RECEIPT DATE: 7/17/2015 **ONSITE SEWAGE DISPOSAL SYSTEM**

PROPERTY ADDRESS: 720 Woodbine Crossing

WALL CHECK DRAWING
LOT 13
WOODBINE CROSSING

RE: BAT Site Plan Review Comments
Woodbine Crossing, Lot 13

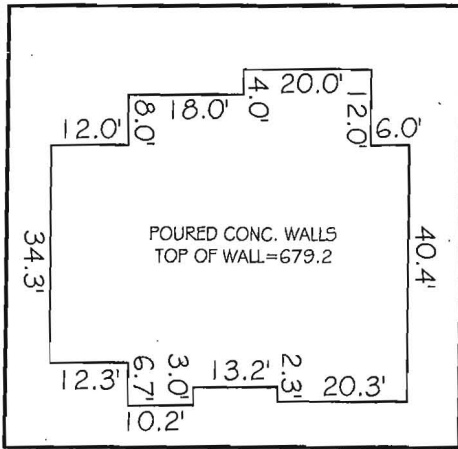
*House is rotated
a little clockwise
from Site Plan.
Wall check OK!
reb 7/17/2015*

WELL SITE PLAN

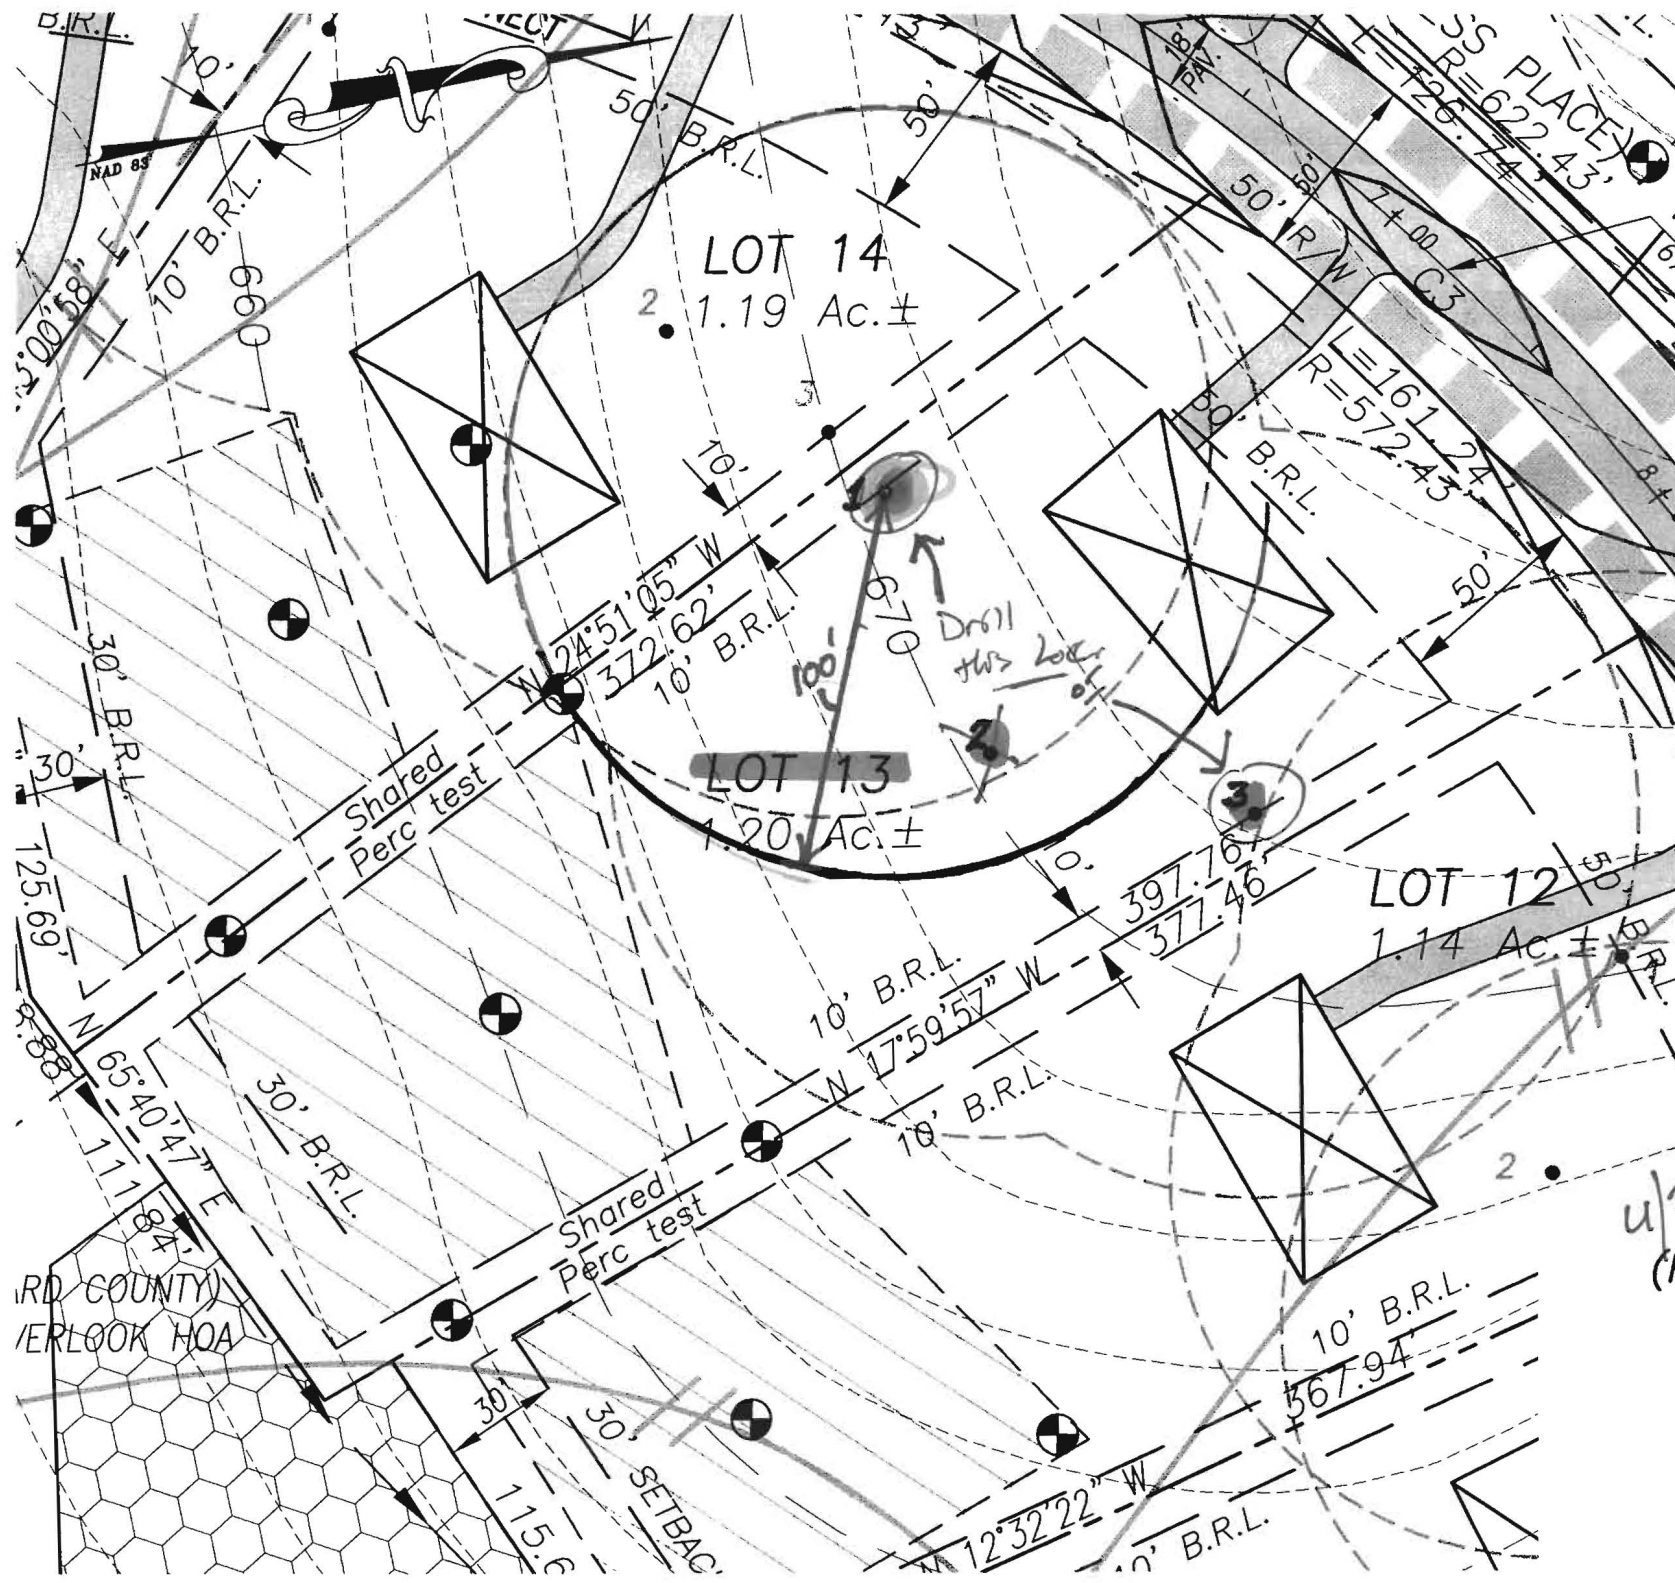
As stated in the response (below) on May 13th, all well sites must meet setback requirements so that they are in compliance in the event they are needed in the future. It is suggested that the septic tank be relocated to the other side of the septic trenches in order to be out of the 100 foot well radius of the alternate well site.

1. Foundation needs to be 30' from all wells. It is 100' from the drilled well. Is there some allowance even for alternate well locations that will never be drilled. Can I adjust the alternate well locations to be 30 as long as they meet the other setback requirements. Well boxes and alternative well sites must meet all well setbacks so that they are in compliance in the event they are needed, similar to a sewage disposal area for future repairs. We have run into problems in the past with well sites being moved on building permit plans and years later, it is

- 2.
2. If the septic tank is down slope of the well, can it be only 50' from the well? COMAR 26.04.02 is clear that wells must be located 100' from any sewage disposal system, which includes the tank and drainfield. A deviation from that would require a variance from MDE, which they would never do for new construction. Even on repairs they don't typically vary more than 10 feet or so inside of 100.

1. All well sites need to be located at least 30 feet from new foundation. Adjust new foundation accordingly.
2. All septic components must be located at least 100 feet from all well sites. Move septic tank outside of well radius.
3. Floor plans show 5 bedrooms by definition but BAT Plan is only sized for 4 BRs. Adjust BAT Plan or builder will have to revise Floor Plan.

Response 1: House foundation has been moved to be 30 feet from all well sites.

Response 2: Septic tank has been relocated outside the well radius.

Response 3: The BAT Plan has been adjusted to be sized for 5 bedrooms.
